Access Compliance Report Public Rights-of-Way (Curb Ramps)

Main Street: BRYANT_CT Cross Street: CLYDESDALE_DR Location: SE

ADA ID: RPRK211112120939 Ramp Type: Type 4 - Parallel Initial Pass/Fail: Fail Overall Compliance: No Severity Score: 15

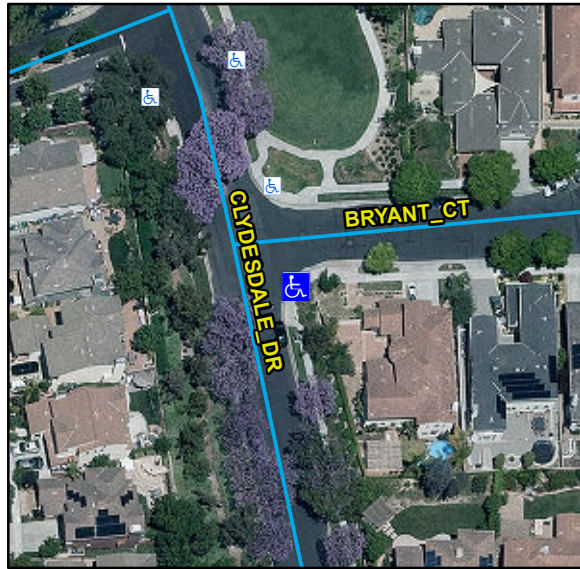
Compliance	Description	Data	Compliance	Description	Data
N/A	Ramp Length LT (in)	139	N/A	Ramp Length RT (in)	135
Yes	Ramp Width LT (in)	54	Yes	Ramp Width RT (in)	53
No	Ramp Run Slope LT (%)	10.2	Yes	Ramp Run Slope RT (%)	1.5
Yes	Ramp Cross Slope LT (%)	1.8	Yes	Ramp Cross Slope RT (%)	0.7
N/A	Landing Present	N/A	N/A	DWS Provided	N/A
N/A	Landing Length (in)	N/A	N/A	DWS Contrast	N/A
N/A	Landing Width (in)	N/A	N/A	DWS Length (in)	N/A
N/A	Landing Run Slope (%)	N/A	N/A	DWS Full Width	N/A
N/A	Landing Cross Slope (%)	N/A		DWS Offset Type	N/A
N/A	Landing Movement Obstructed?	N/A	N/A	DWS Offset Left (in)	N/A
	Landing Movement Type	N/A	N/A	DWS Offset Right (in)	N/A
N/A	Landing Shared	N/A			
N/A	Clear Space	Yes			
N/A	Clear Space To Crosswalk (in)	N/A			
N/A	Marked Crosswalk 1	No	N/A	Marked Crosswalk 2	No
	Crossing 1 Direction	N		Crossing 2 Direction	W
	Marked Crosswalk 1 Width (in)	N/A		Marked Crosswalk 2 Width (in)	N/A

Remove & Replace Curb Ramp With Two New Directional Ramps or Equivalent.
